Technical Evaluation Report

For the Revised Performance Assessment for the Saltstone Disposal Facility at the Savannah River Site, South Carolina

U.S. Nuclear Regulatory Commission
Office Of Federal And State Materials
And Environmental Management Programs
Washington, DC 20555-0001

APRIL 2012

Figure 2.5-2: DOE Case A modeled Hydraulic Conductivity and Diffusion Coefficient for HDPE Lining of FDCs After Closure (2009 PA, Figure 4.2-42)

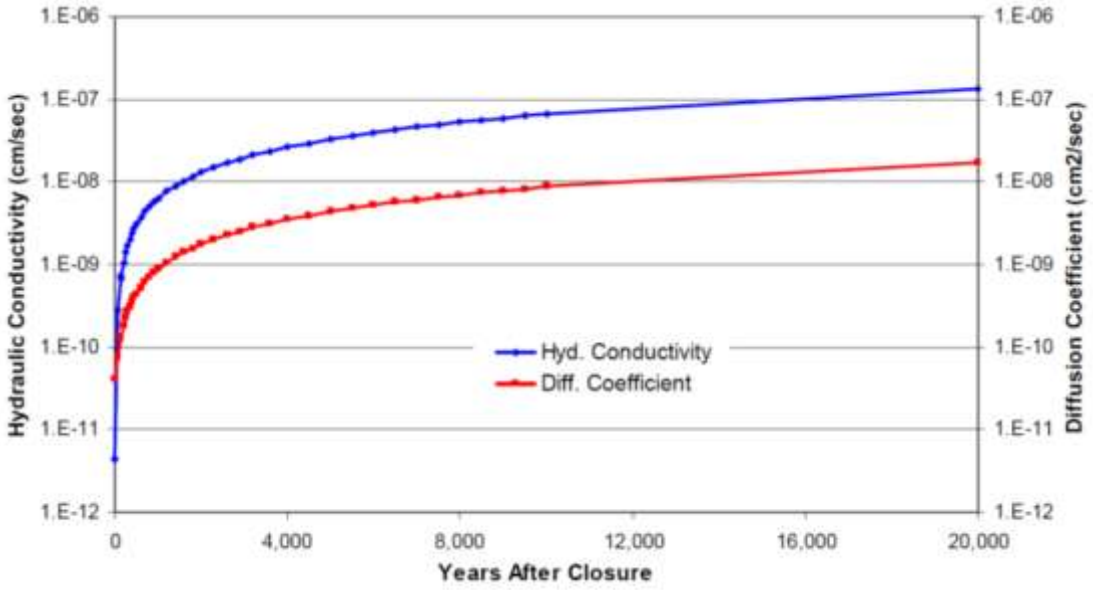
[9] The reported initial hydraulic conductivity of HDPE is significantly different from the value of $5.9x10^{-10}$ cm/s used in the first modeling times step, as presented in SRNL-STI-2009-00115, Appendix E (unnumbered table on page 234). These values differ by more than the expected difference between the initial values and the average values for the first time step. Both of these values differ from the initial value depicted in Figure 2.5-2.

Figure 2.7-1: Vertical Darcy velocity through saltstone in Vault 4 predicted with the DOE PORFLOW™ model. Data for the Synergistic Case excludes fractures (other cases do not represent fractures explicitly). Data taken from DOE's STAT.out files (NRC, 2010g).

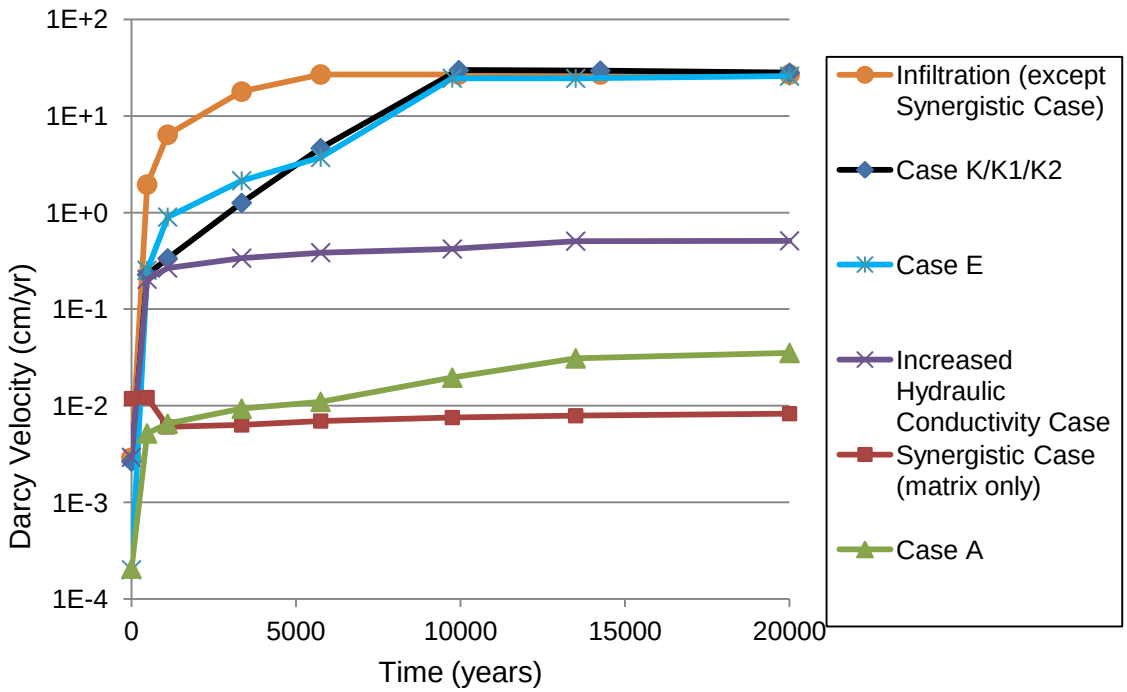
As discussed in more detail in Sections 2.5 and 2.6, the NRC staff found that the assumed low hydraulic conductivities of saltstone and the disposal unit concrete used in Case A and many of the deterministic sensitivity cases were overly optimistic. Similarly, assumptions regarding the performance of the lateral drainage layer, the disposal unit roofs, and the HDPE/GCL layer (for the FDCs) resulted in a significant amount (i.e., greater than 99% of the infiltrating water being shed around the disposal units even 10,000 years after site closure in Case A and several of the deterministic sensitivity analyses (Section 2.5) (SRR-CWDA-2011-00044; IEC-8). As discussed in Sections 2.5 and 2.6, the NRC staff finds that Cases K, K1, and K2 more realistically represent the current and expected future hydraulic and physical properties of the saltstone and disposal units. In these cases, the modeled flow through the saltstone and disposal units does not appear to be inappropriately constrained (Figures 2.7-1, 2.7-2, and 2.13-1).

With respect to flow modeling, the NRC's analysis of DOE's near-field model indicates that Case A appears to severely constrain flow through saltstone (Figures 2.7-1 and 2.7-2). As discussed in detail in Section 2.6, the saltstone hydraulic conductivity that contributes to this low flow value is inconsistent with recent measurements and does not reflect any degradation of the hydraulic conductivity as the saltstone ages. Flow through the saltstone and disposal unit concrete in the PA Cases (i.e., cases other than Cases K, K1, and K2) were further limited by moisture characteristic curves that are inconsistent with curves found in the literature for similar materials. DOE demonstrated that the effect of the suspect moisture characteristic curves is limited to a factor of 2 in Case A (Section 2.7.3), however, the effect may be greater if other engineered barriers do not perform as modeled. Because of the large uncertainty in the potential degradation of saltstone, disposal unit concrete, and the HDPE/GCL layers on the FDCs, and because of the importance of these barriers to system performance (Section 2.13), the NRC staff will monitor the development of model support for the long-term performance of these materials.

Figure 2.7-3: Moisture Characteristic Curves Adapted from the PA and WSRC-STI-2006-00198 (SRR-CWDA-2010-00033; Figure 1)

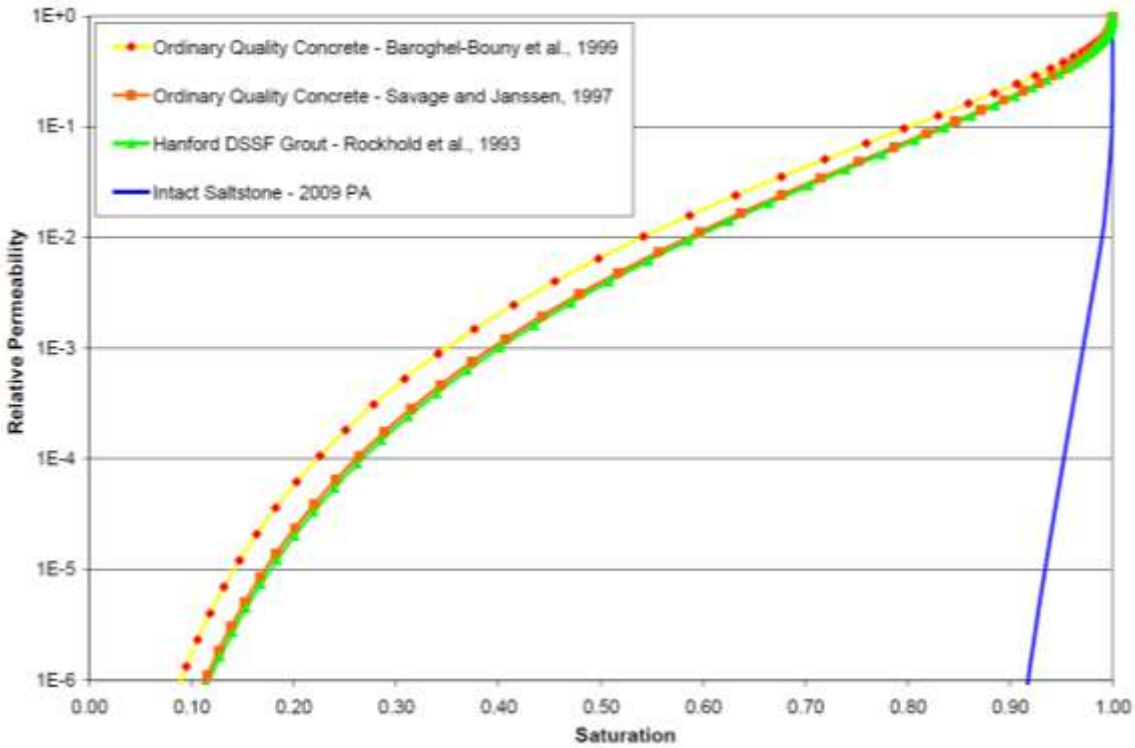
In response to NRC's concern about the moisture characteristic curves in intact saltstone, DOE agreed that the moisture characteristic curve utilized in the PA for intact saltstone is inconsistent with the literature (SRR-CWDA-2010-00033; SP-3). To evaluate the impact of moisture characteristic curves, DOE performed a sensitivity case based on Case A with the relative permeability for intact saltstone fixed at 1.0 (i.e., the hydraulic conductivity was not reduced based on moisture characteristic curves) for the most risk significant radionuclides. The resulting contaminant release rate was approximately twice that of the original Case A result for an FDC within 10,000 years after site closure. For Vault 4, with the relative permeability equal to 1.0, the release rate of Tc-99 was almost doubled, while the I-129 and Ra-226 rates increased by less than 30% as compared to the original Case A values. DOE stated that these increases in release rates would not significantly impact the resulting dose to the member of the public. In addition, DOE performed a sensitivity case based on the Synergistic Case with a revised saltstone relative permeability of 1.0 and concluded that the sensitivity case showed no significant impact on the resulting dose (SRR-CWDA-2010-00033, VP-2). Based on these analyses, DOE concluded that the moisture characteristic curve used in the PA for intact saltstone does not appreciably impact the estimated dose to the member of the public.

Figure 2.7-4: Characteristic curves for the intact and fractured saltstone and concrete as adapted from the 2009 PA and SRNL-STI-2009-00115 (SRR-CWDA-2010-00033; Figure 2)

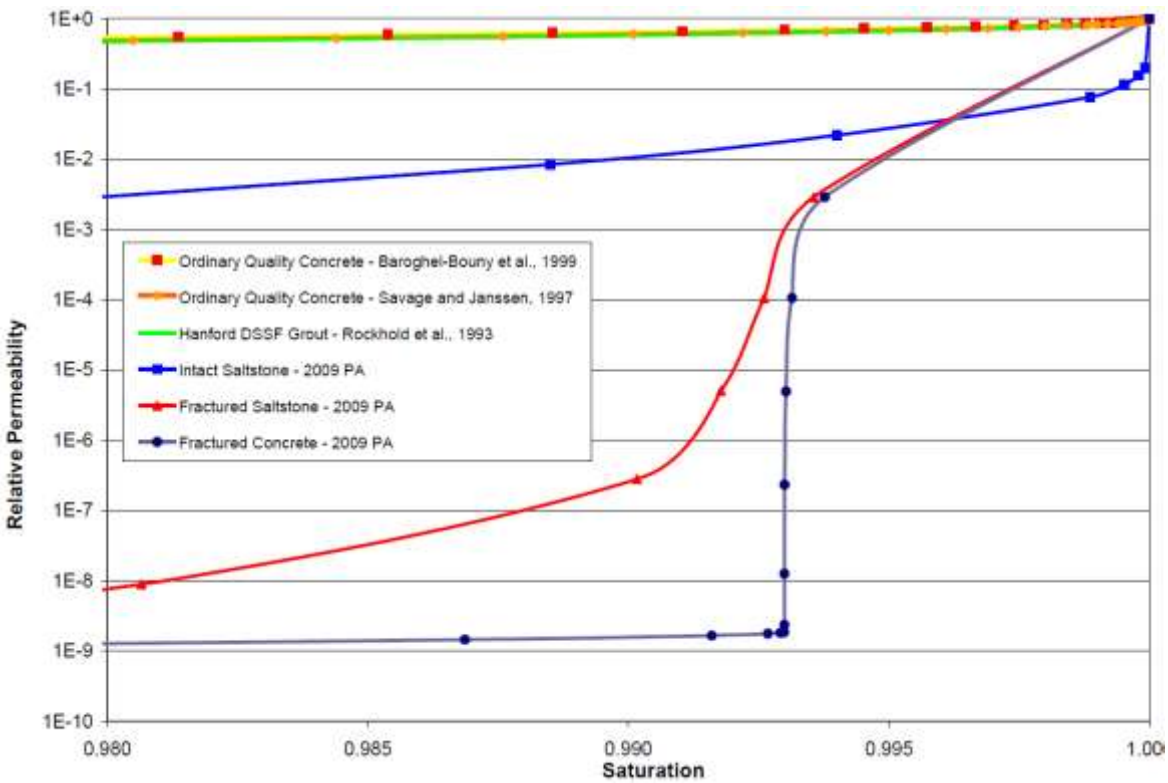
However, as NRC indicated in response to these DOE analyses (NRC, 2010i; SP-3), one-off sensitivity analyses may result in insignificant increases in the dose on an absolute basis; however, the effect on dose results may be significant when there are many outstanding uncertainties that are evaluated on a cumulative basis. In response to the second RAI (SRR-CWDA-2011-00044), the DOE provided a more comprehensive analysis, Case K, to address the NRC staff's concern with DOE's moisture characteristic curve for intact saltstone as well as other concerns. In this analysis, DOE fixed the relative permeability to one for the cementitious materials (i.e., moisture characteristic curves were not used). NRC staff finds that this approach is reasonable due to the (i) uncertainty in unsaturated flow through cementitious materials over long periods of time and (ii) limited amount of reduction in flow that would be expected for cementitious materials that are predicted by DOE to be near saturation. Case K also addressed NRC staff's concern with the moisture characteristic curves that were used to represent unsaturated flow through fractured saltstone and concrete.

DOE used an analytical approach to develop curves for fractured cementitious materials in the PA based on the moisture characteristic curves that were to represent intact saltstone. Figure 2 of the first RAI response (SRR-CWDA-2010-00033) shows the curves for fractured saltstone (used to represent the saltstone grout in Case E) and fracture concrete (used to represent the walls of Vaults 1 and 4 in all of the cases in the PA except the Synergistic Case) (Appendix E of SRNL-STI-2009-00115; SRR-CWDA-2010-00033). The figure illustrates that a decrease in the saturation of the walls of Vaults 1 and 4 from 100% to 99% results in an unrealistic decrease of nine orders of magnitude in relative permeability. The NRC staff's concern, as discussed in the

Figure 2.8-6: Calibrated Horizontal Hydraulic Conductivity Assignments to the Regional GSA/PORFLOW™ Model (Fourmile Branch is to the South and Upper Three Runs Creek is to the North on the GSA [2009 PA, Figure 4.2-10, pg 176])

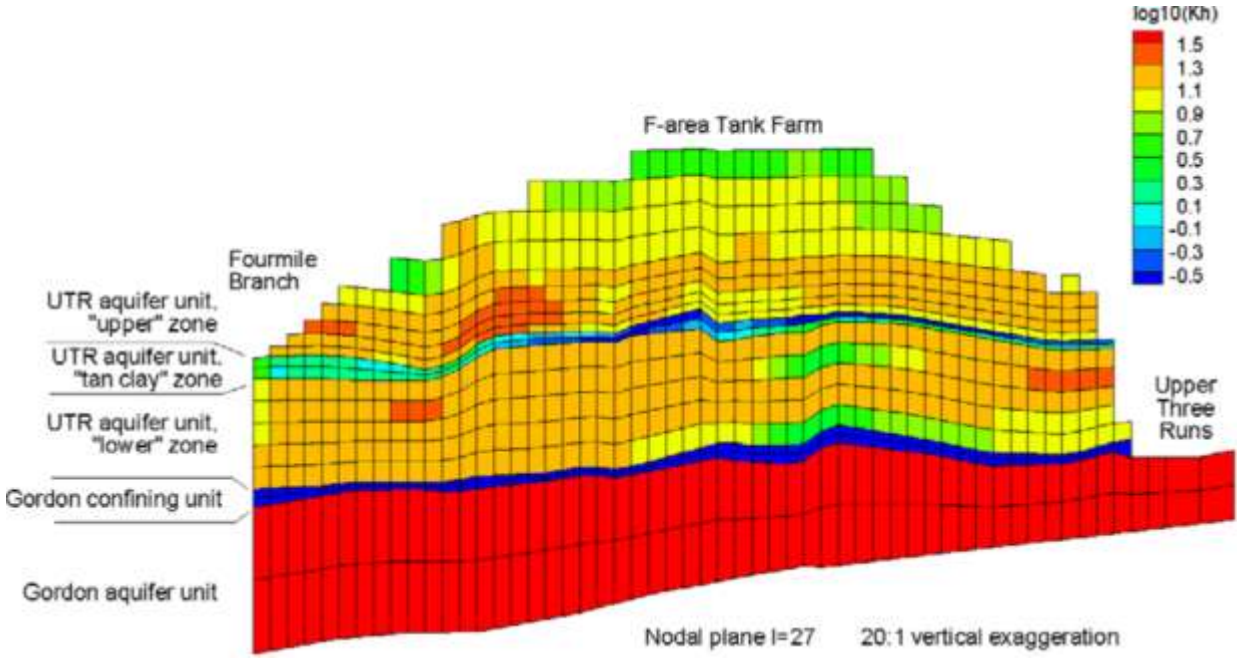
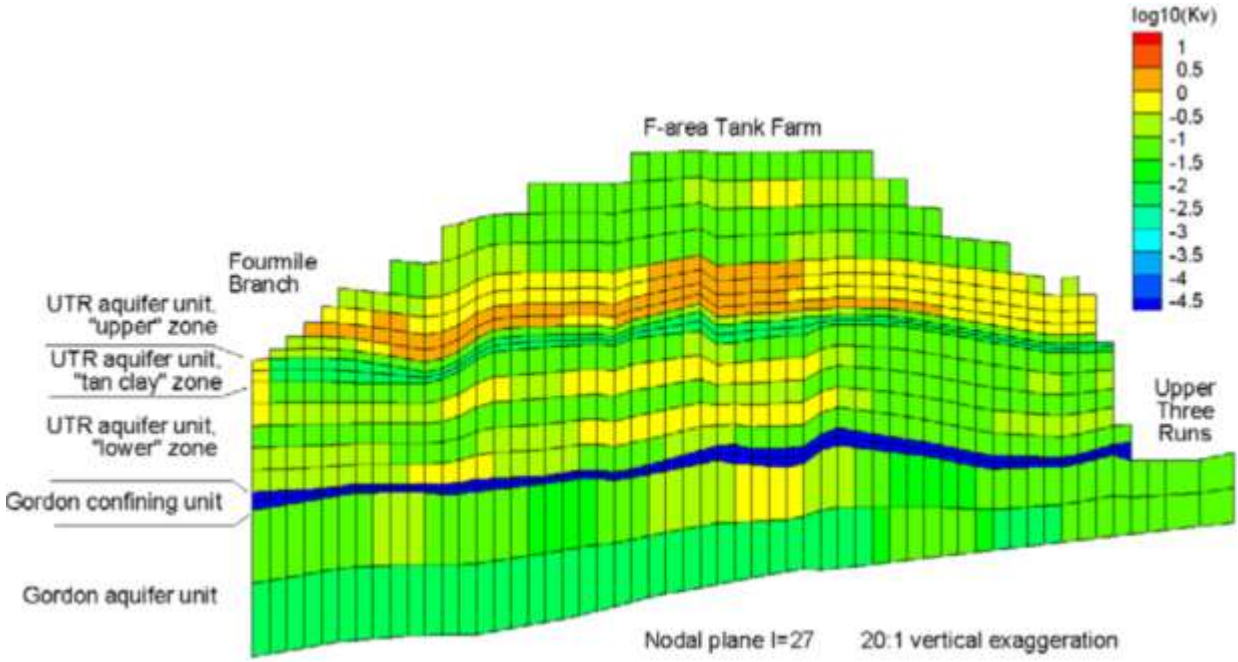
Summary statistics for hydraulic head residuals were provided in the GSA/PORFLOW™ documentation (WSRC-TR-2004-00106, Table 3-1); however, no calibration goals were specified. GSA/FACT documentation (WSRC-TR-96-0399, Vol 2 Rev. 1) indicates that calibration criteria should be no more stringent than the uncertainty in the data. Hydraulic head data was reported as having a maximum uncertainty of 1 m (3 ft) (WSRC-TR-96-0399, Vol 2 Rev. 1). Therefore, a calibration goal of 1 m (3 ft) for the root-mean-square hydraulic head residual was set for the regional GSA/FACT model. WSRC-TR-96-0399, Vol. 2 Rev. 1 also defines a calibration goal for the maximum head residual as 5 to 10 percent of the total hydraulic head variation in a given aquifer. Total hydraulic head variation within the Gordon aquifer is given as ~24 m (~80 ft). Therefore, a maximum target head residual would be no greater than 1.2 to 2.4 m (4 to 8 ft) for the Gordon aquifer. Total head variation within the UTR aquifer is given as ~49 m (~160 ft). Therefore, a maximum target head residual would be no greater than 2.4 to 4.9 m (8 to 16 ft) for the UTR aquifer. While no specific calibration goals are set for the GSA/PORFLOW™ model, the maximum residual in the UTR-LZ of 8.2 m (27 ft) near H-Area in the GSA/PORFLOW™ model greatly exceeds the calibration goal indicated in the GSA/FACT model. WSRC-TR-2004-00106 indicates that head residuals for the GSA/PORLOW model are somewhat larger than those for GSA/FACT for various reasons (e.g., use of an artificial recharge zone near H-Area and finer vertical discretization in the GSA/FACT model) and that more extensive calibration efforts would likely improve the GSA/PORFLOW™ model.

With regard to calibration in the area of interest, few calibration targets appear to be located in the vicinity of the SDF. Although Figure 4.2-14 in the 2009 PA provides comparisons of hand-contoured water table elevations based on monitoring data versus modeled heads (pg 180),

Figure 2.13-4: Water shedding around Vault 4 in DOE Case A at 0 and 8,000 years after site closure (left top and bottom) as compared to an NRC interpretation of know conditions (top right) or potential future conditions considering uncertainty (bottom right)

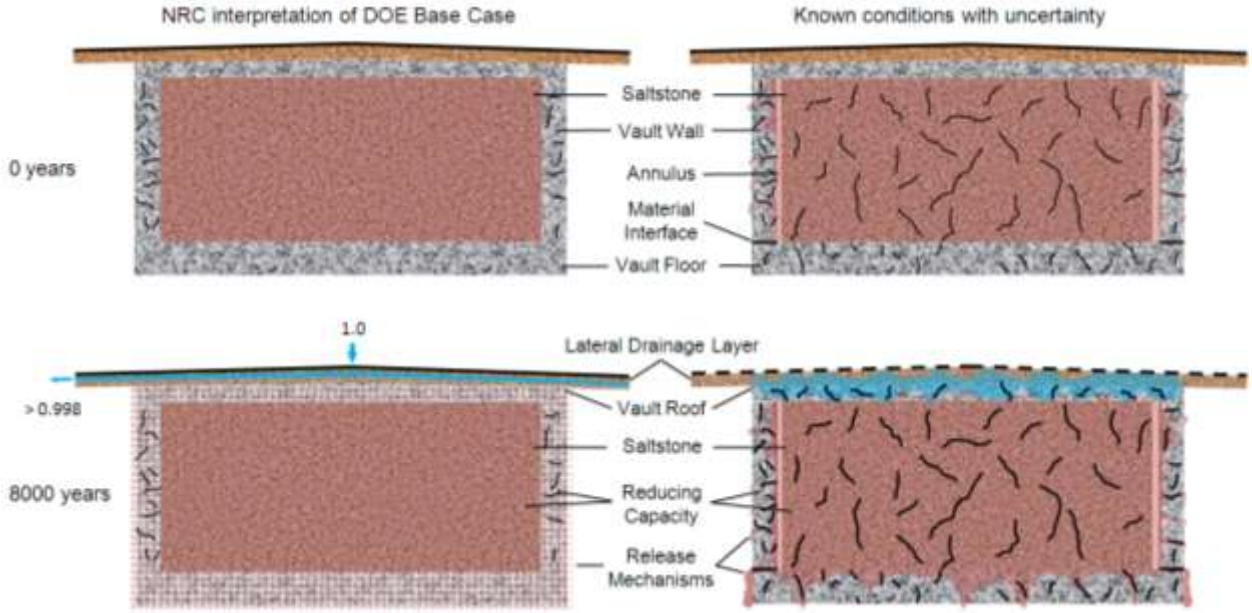
drainage layer, demonstrates the importance of the large contrast between the modeled hydraulic conductivity of the lower lateral drainage layer and the layers it overlies above each disposal unit (i.e., the roof for Vault 1 and 4, the HDPE, geosynthetic clay liner, and roof for the FDCs).

Figure 2.13-7 Intermediate results from DOE PORFLOW™ model for Case K, showing Tc release from Saltstone and re-concentration in the FDC floor and walls. At approximately 13,000 years after closure, over 90% of the Tc inventory originally in saltstone is present in the FDC floor and walls.

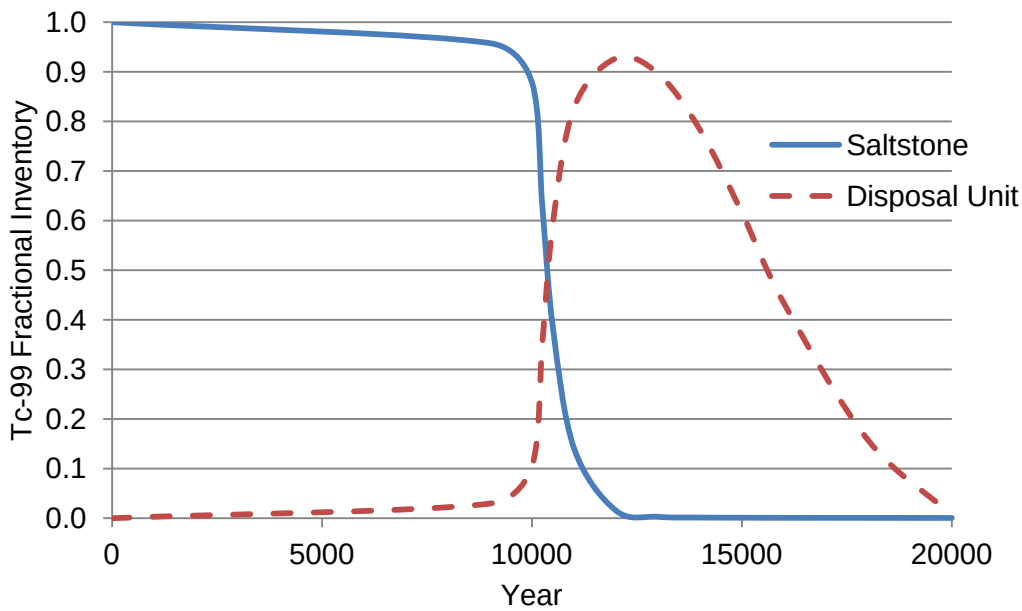
The two primary effects of this reconcentration in the disposal unit floor and walls are to delay the peak dose by approximately 5,000 years and to significantly reduce the magnitude of the peak dose. Peak doses are reduced because the peak dose is very sensitive to the rate at which Tc is released into the environment, and the modeled Tc release from the disposal units is much slower than the modeled Tc release from the saltstone.

Figure 2.13-8 Comparison of annual fractional release from saltstone predicted by NRC's simple analytical average-K_d and dual-K_d models, using DOE Case K1 fracturing, near-field flow, and K_d values. Both models simulate the same cumulative release.

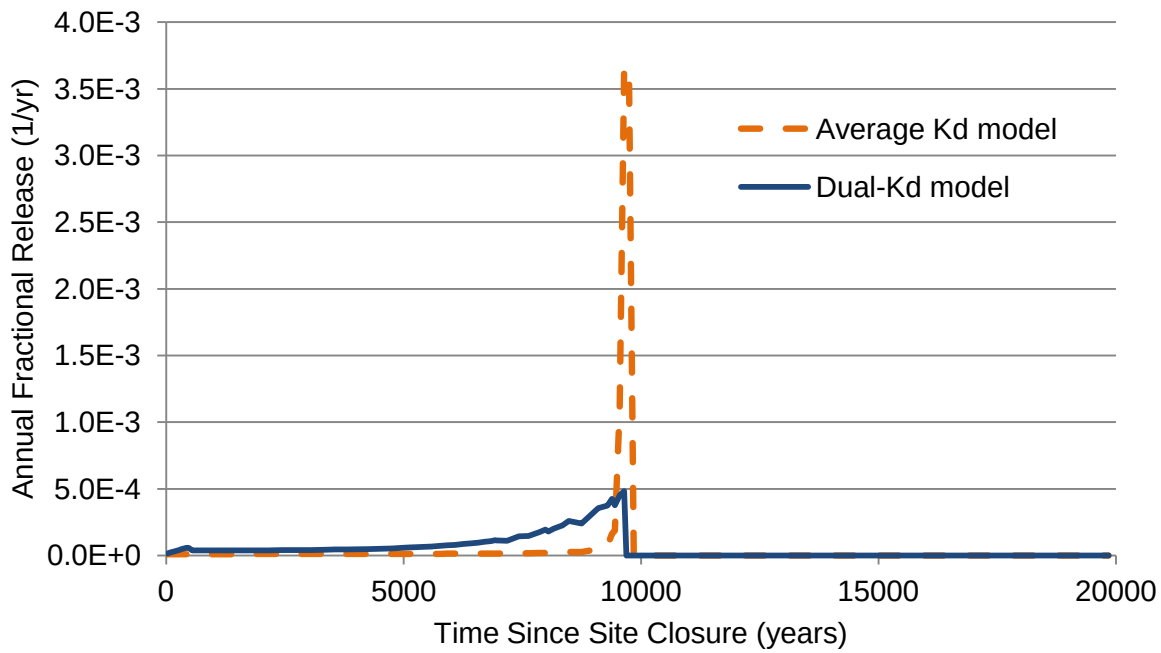
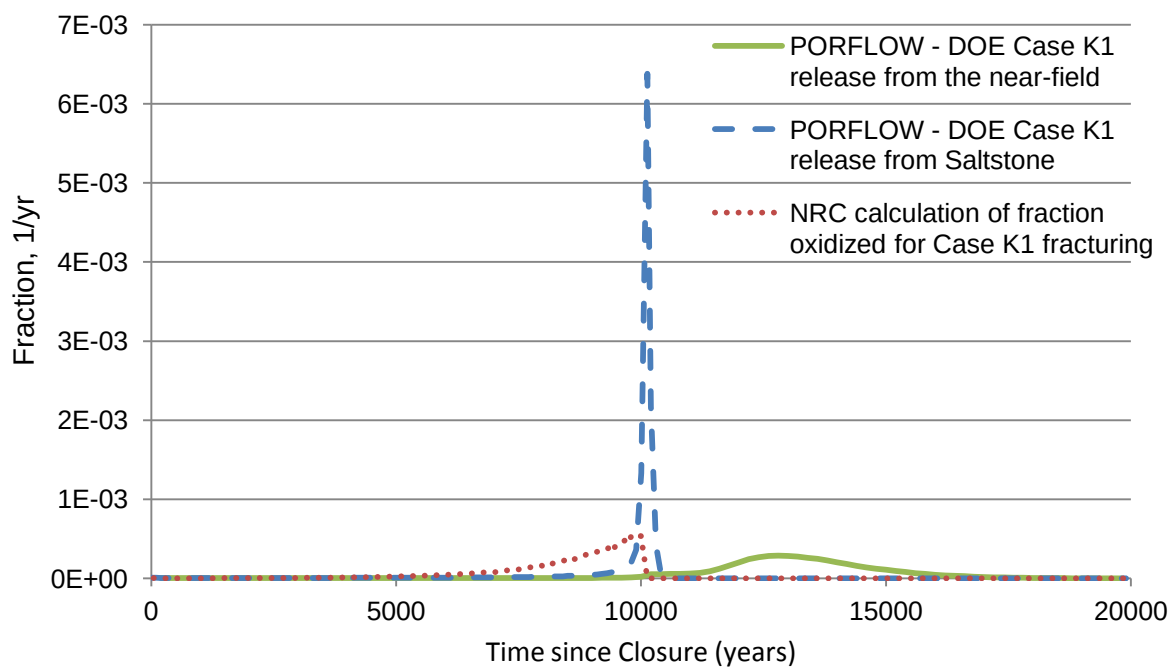
Comparison of the simple average-K_d and dual-K_d models indicates that the average-K_d model can under-predict releases in the short-term and significantly over-predict peak release rates in some cases (Figure 2.13-5). The NRC staff calculations indicate the average-K_d model over-predicts release rates most significantly in cases in which most of the release comes from the oxidized, rather than the reduced, fraction of saltstone. Thus the effect is most pronounced when there is relatively low water flow through saltstone to release Tc from the reduced region before significant oxidation occurs. Comparison of model results indicates that the dual-K_d model allows a more gradual release of radionuclides, resulting in a smaller available inventory at times when the average-K_d model would predict nearly the entire initial inventory is released with a relatively low average sorption coefficient. This result is similar to the result of DOE's comparison of an average-K_d model and a dual-K_d model (which DOE refers to as single- and dual-porosity models) (SRR-CWDA-2011-00114), although the NRC staff's simplified models predicted a more substantial difference between the two approaches than predicted by DOE. The magnitude of the overprediction of peak dose that both NRC and DOE expect the average-K_d model to cause is unclear. DOE's conclusion that the average-K_d model provides a good representation of Tc release is based on a comparison of two GoldSim® models rather than a comparison involving the actual PORFLOW™ model DOE used to model Tc release. NRC staff concluded DOE's GoldSim® comparison was likely to underestimate the difference between the models, as compared to a similar comparison performed in PORFLOW, because of certain implementation details in DOE's GoldSim® models (Section 2.7). However, the DOE models include diffusion between the oxidized and reduced regions, which is an important process not included in the simplified NRC staff models. In DOE's Case K, K1, and K2 analyses, the expected over-prediction of peak dose attributable to the average-K_d model is further obscured by the re-concentration and gradual re-release of Tc from the disposal unit floor and walls (Figure 2.13-7).

In addition to evaluating the applicability of the average-K_d model, the NRC staff's analytical calculations based on the simple dual-K_d model were used to map a greater range of parameter variation than could be addressed efficiently with variations in the DOE Case K1 PORFLOW™ model. The NRC staff did not use these values for comparison to the performance objectives. Rather, these values were used to indicate factors to which the Case K1 dose may be sensitive and to develop an estimate of the uncertainty in the Case K1 value. As previously discussed, this effort was undertaken because the NRC staff concluded the DOE Case K1 average-K_d model overestimated the expected annual fractional release from the saltstone waste form in a way that was difficult to isolate using the PORFLOW™ model. In addition, the effort was necessary because, unlike Cases A - E, Case K1 was supplied without an uncertainty analysis and with limited deterministic sensitivity analysis (i.e., the only sensitivity analysis provided was a comparison of the results of Cases K, K1, and K2, which used different K_d values to represent Tc sorption in saltstone).
